WA STATE ENERGY CODE FORMS

CITY OF MERCER ISLAND

SCOPE OF CHANGE DOES NOT CHANGE SQUARE FOOTAGE OF CONDITIONED SPACE, INCREASES GARAGE AND DECK SQUARE FOOTAGE, NO CHANGE TO MECHANICAL OR

PROJECT TITLE:
Clarkson Residence
8163 West Mercer Way
Mercer Island, WA 98040

EXTERIOR
ELEVATIONS

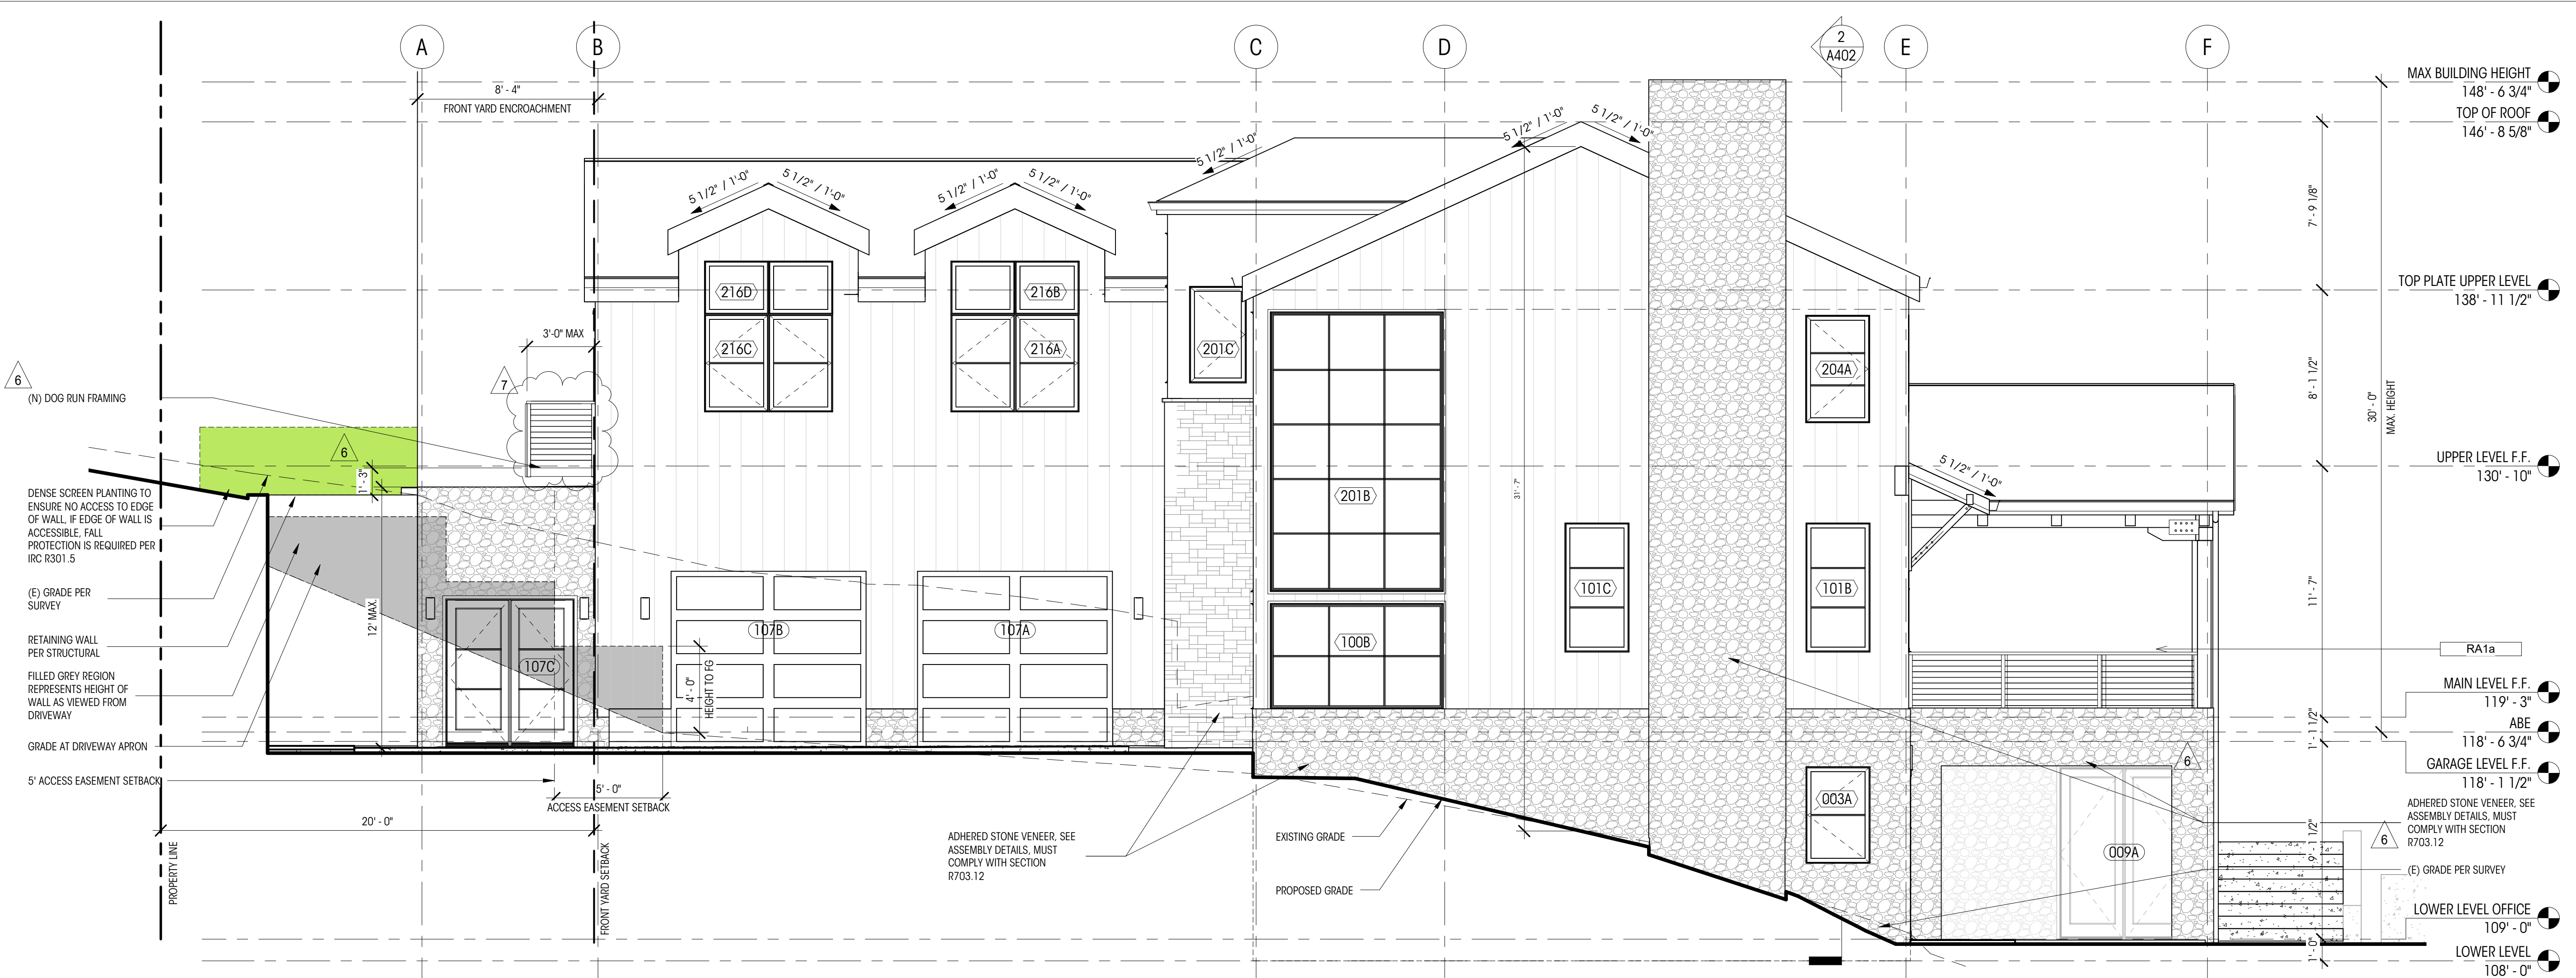
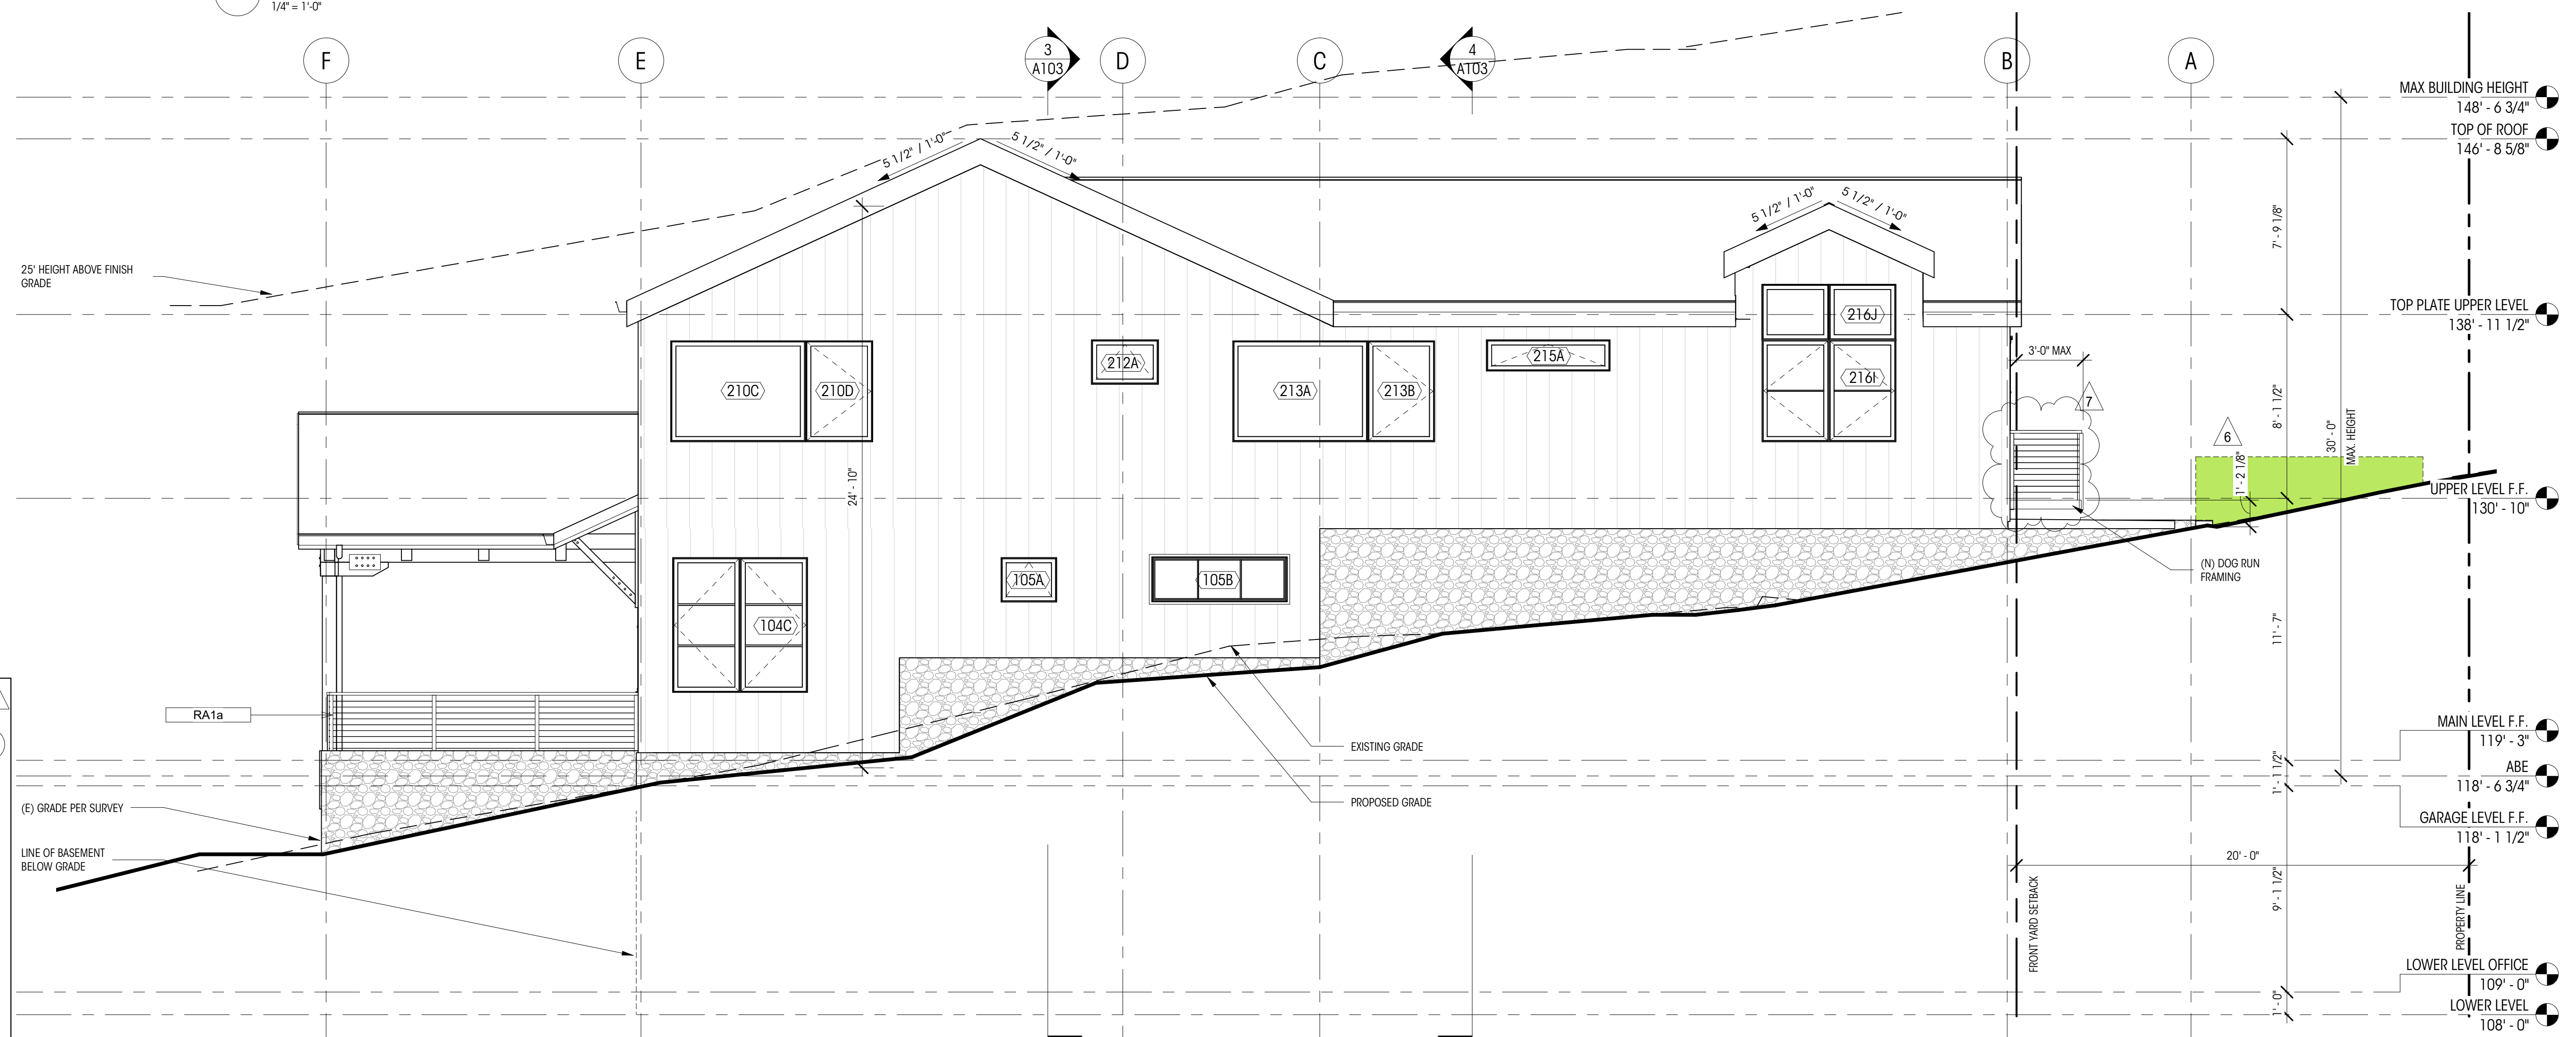
(N) DOG RUN FRAMING
DENSE SCREEN PLANTING TO ENSURE NO ACCESS TO EDGE OF WALL IF EDGE OF WALL IS ACCESSIBLE. FALL PROTECTION IS REQUIRED PER IRC R301.5
(E) GRADE PER SURVEY
RETAINING WALL PER STRUCTURAL
FILLED GREY REGION REPRESENTS HEIGHT OF WALL AS VIEWED FROM DRIVEWAY
GRADE AT DRIVEWAY APRON
5' ACCESS EASEMENT SETBACK
PROPERTY LINE
